SERVICE BULLETIN

04- T2-24

MODELS CONCERNED: C Series with K55 Transmission

CONCERN: Cooling Fan Assembly change

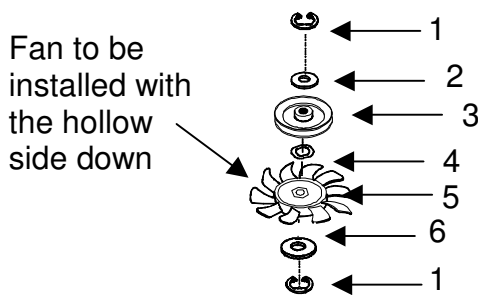
The combined Pulley and Fan 40 5054 00 will no longer be supplied for this Transaxle. Instead a Plastic fan, separate pulley and washers will be supplied. These should be fitted as per the diagram below:

K55 PULLEY & FAN KIT

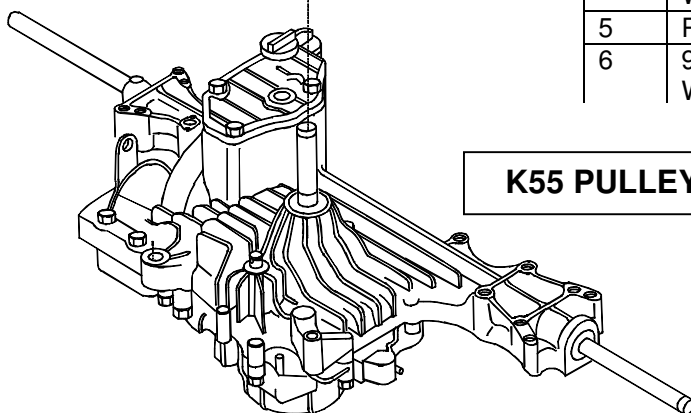
The gear change arm will also need to be removed and bent to match the drawing below. This is to ensure the gear change rod does not foul the fan.
